WATER QUALITY MEMORANDUM

Utah Coal Regulatory Program

RE: 2010 First Quarter Water Monitoring, PacifiCorp, Deer Creek Mine. C/015/0018, Task ID #3474

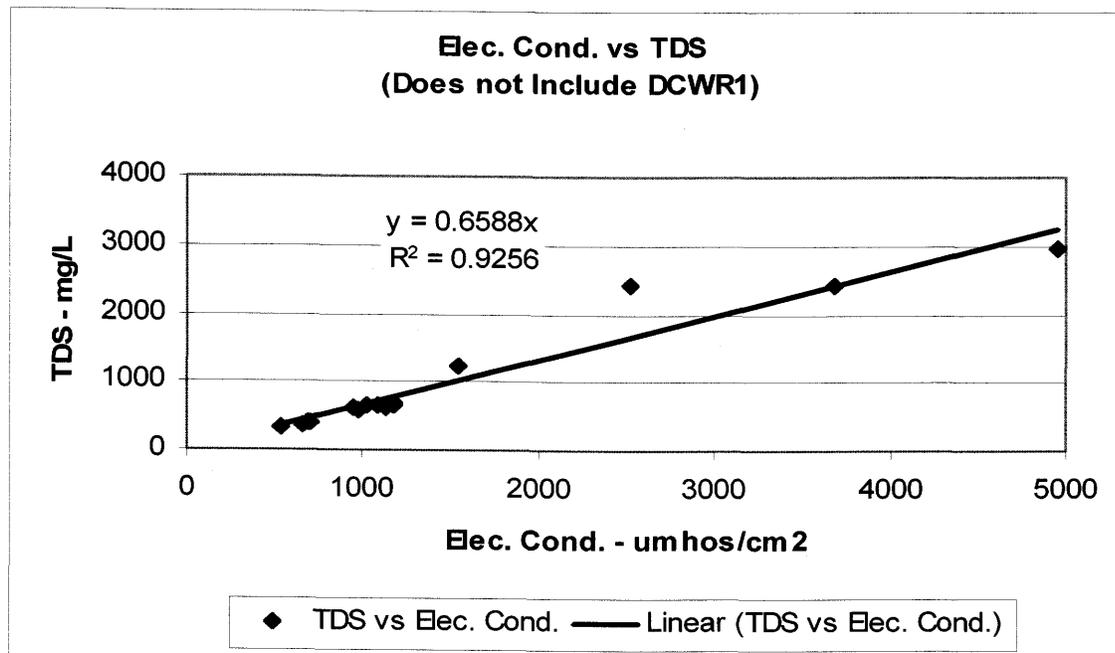
The TDS/field electric conductivity ratio typically falls between 0.55 and 0.76 for dissolved solids concentrations found in natural waters. As the following chart and table show, data for these two parameters submitted for the First Quarter 2010 at the Deer Creek Mine generally result in a ratio that falls within this range.

However, the ratios at RCW-4, Mine Site 4, and DCWR1 (not shown on the chart) are outside the expected range, possibly because of the higher TDS levels in those waters. The March 1 sample from UT0023604-001 had a higher TDS value than RCW-4 and Mine Site 4 and the January 5 TDS was higher than that at RCW4, yet the TDS/field electric conductivity ratios for both are in the expected range, so high TDS alone does appear to be the sole cause of higher TDS/field electric conductivity ratios.
